REGIONAL REVIEW NOTIFICATION

ARC REVIEW CODE: R1808061

Name of Proposal: Decatur Landing (DRI 2820)

DECATUR LANDING DRI
DeKalb County
Natural Resources Group Review Comments
July 31, 2018

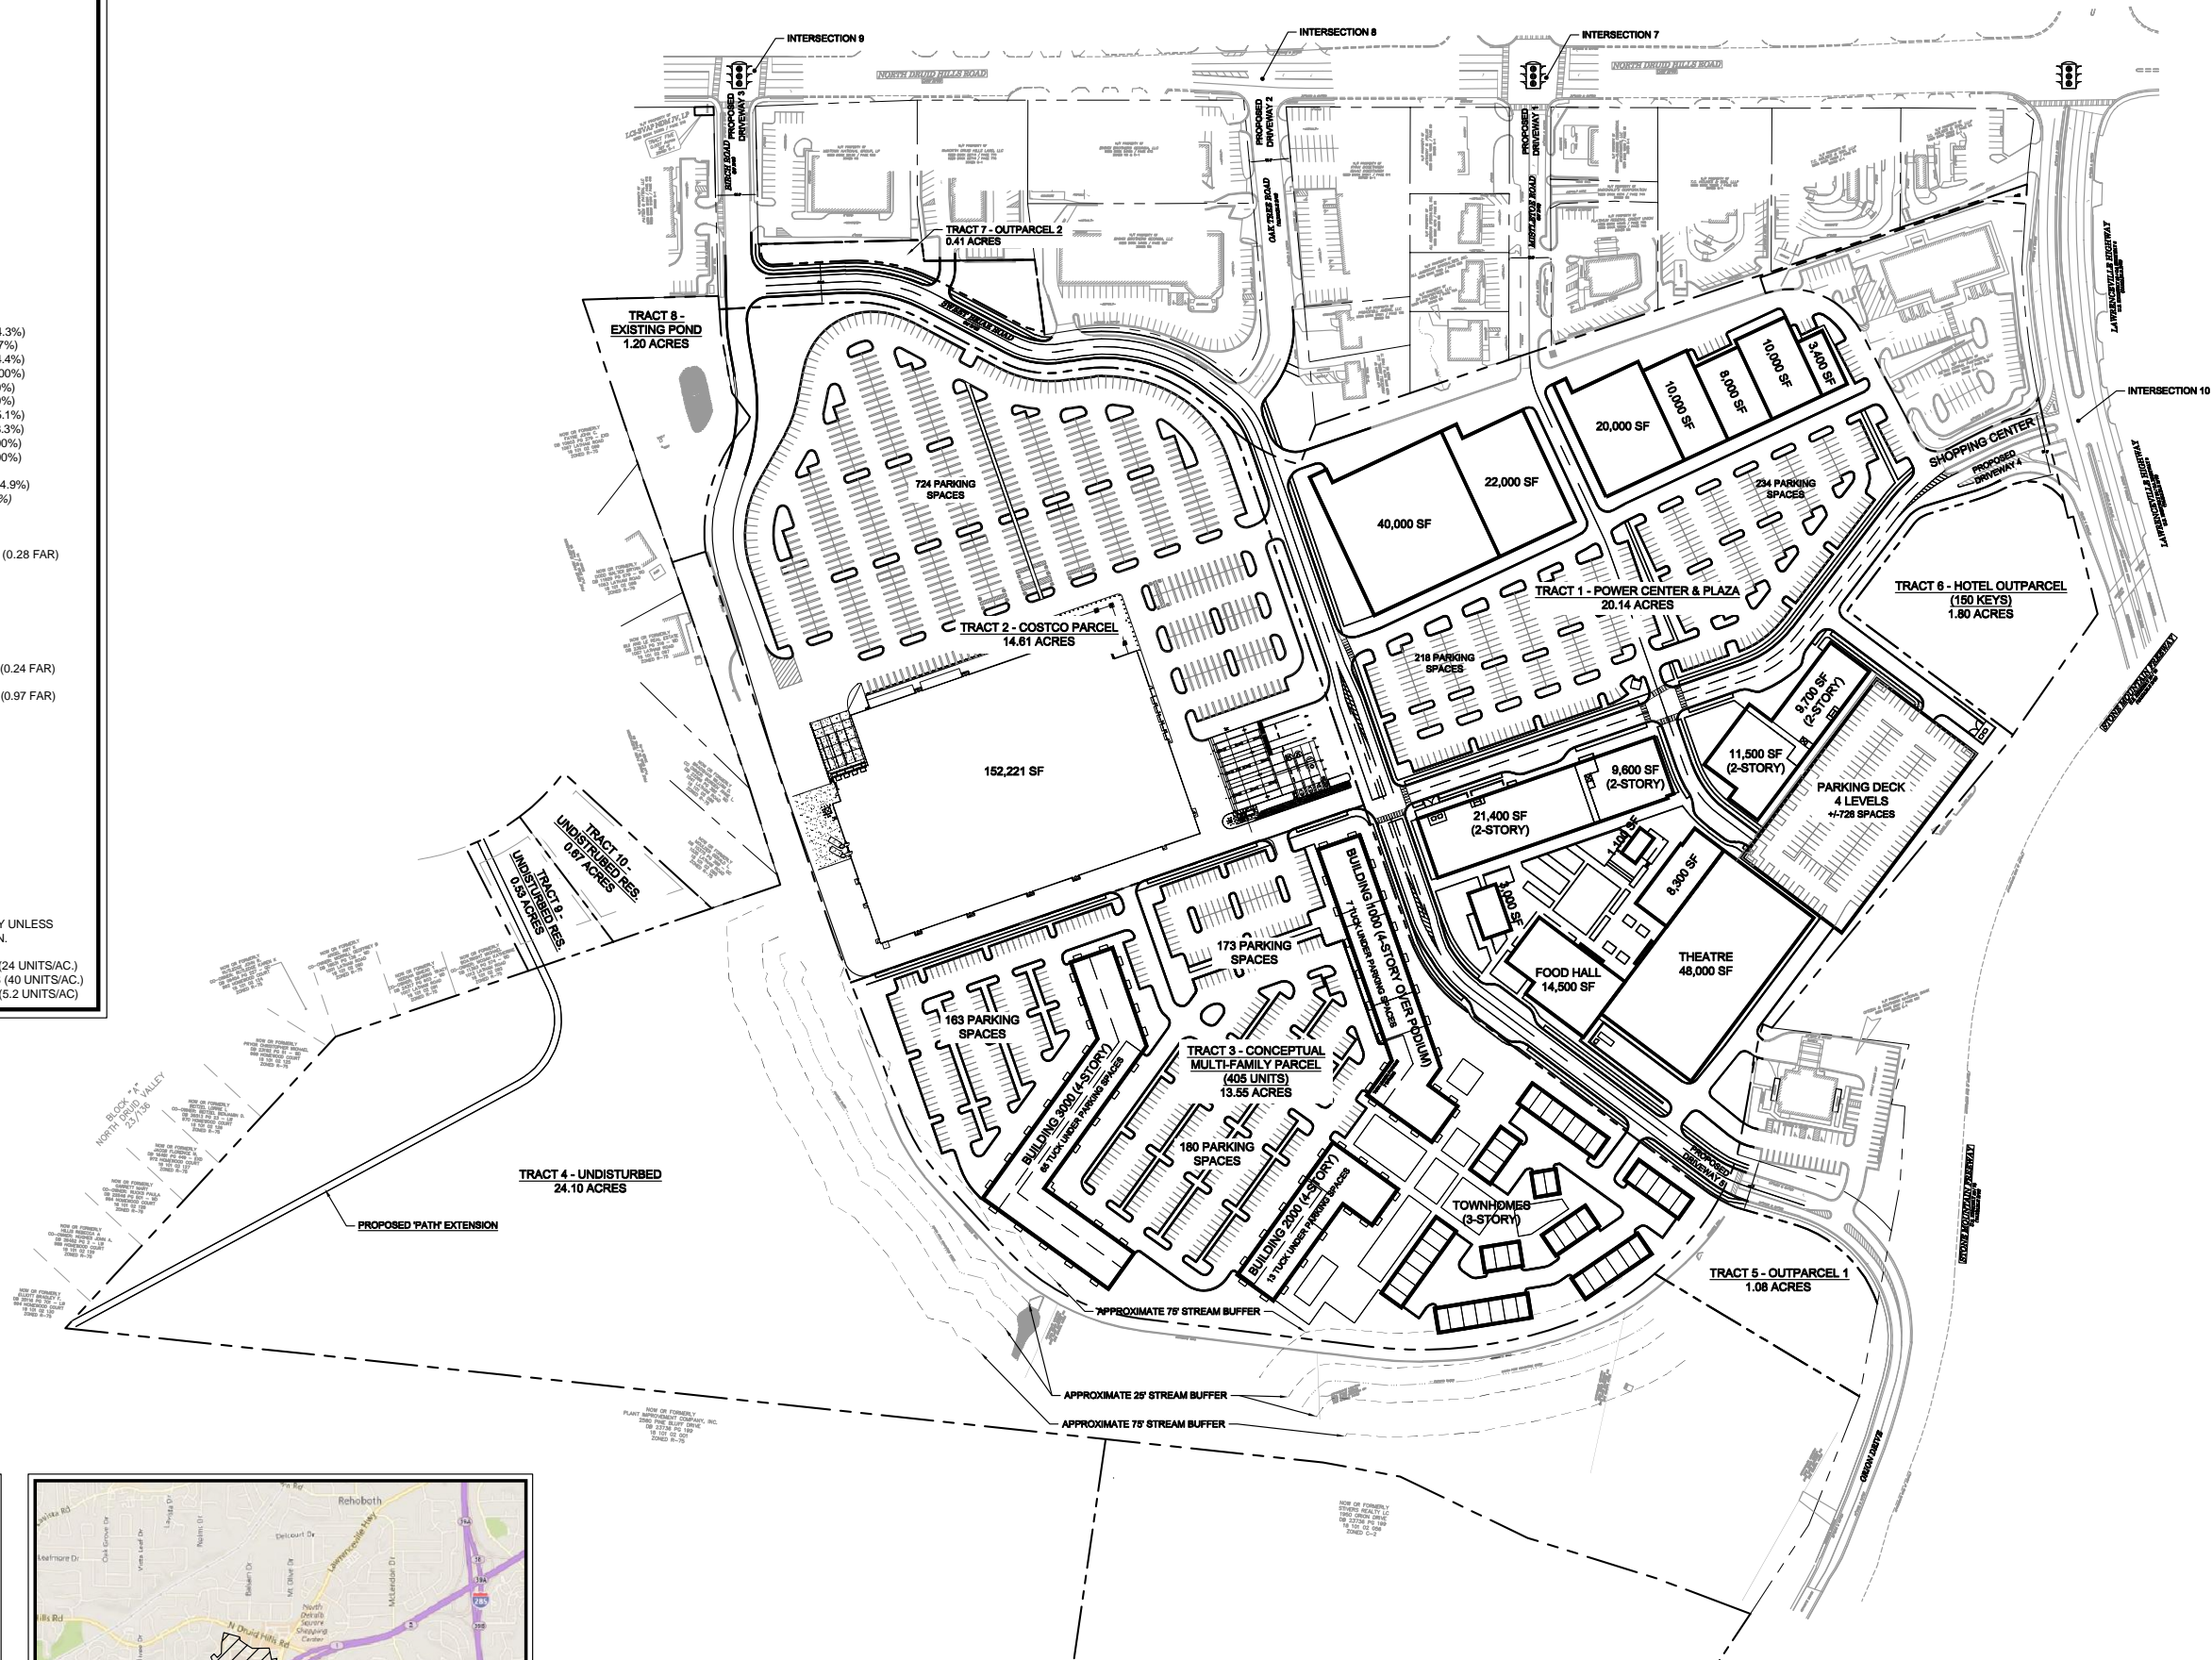
To capitalize on this potential, care should be taken to ensure that the development promotes an interconnected, functional, clearly marked and comfortable pedestrian experience on all streets, paths and parking areas. This is particularly important in terms of connections between each tract within the site, some of which are oriented very differently, for different user groups. Both Tract 2/Costco and the strip retail on the north side of Tract 1 are more automobile-oriented, and are separated by considerable distance and street crossings from the more pedestrian-oriented activity node in Tract 1, around the food hall/movie theater plaza and residential area plaza. Tract 2/Costco is particularly disconnected from the rest of the development. There is no apparent pedestrian pathway or crosswalk connecting Costco, which is

oriented toward its parking lot and N. Druid Hills Rd., to any other part of the DRI. Finally, while Tracts 1 and 3 adjoin each other on the south side of the site, it does not appear that there is a crosswalk or other pedestrian facility directly between the food hall/pedestrian plaza in Tract 1 and the residential area/pedestrian plaza in Tract 3. These areas should be more strongly connected across the north-south spine road, and pedestrians – including site residents – should not be expected to cross only at the intersection of the two spine roads to the north. The development team is also encouraged to ensure that end-of-trip facilities (bicycle racks, etc.) are provided for residents, workers and visitors at key locations throughout the site.

pedestrian facilities currently exist along roadways adjacent to the site. The site plan does not appear to provide new or additional bike/ped facilities.

The traffic analysis includes significant reductions in traffic impacts for mixed-use and alternative transportation modes; however, the site design includes a more than 80 percent increase over the required parking. This, coupled with the isolated parking and building separations, promotes a more vehicle-oriented development. The site should maximize the opportunity for creating a more pedestrian/bike-friendly development as well as take advantage of existing facilities.
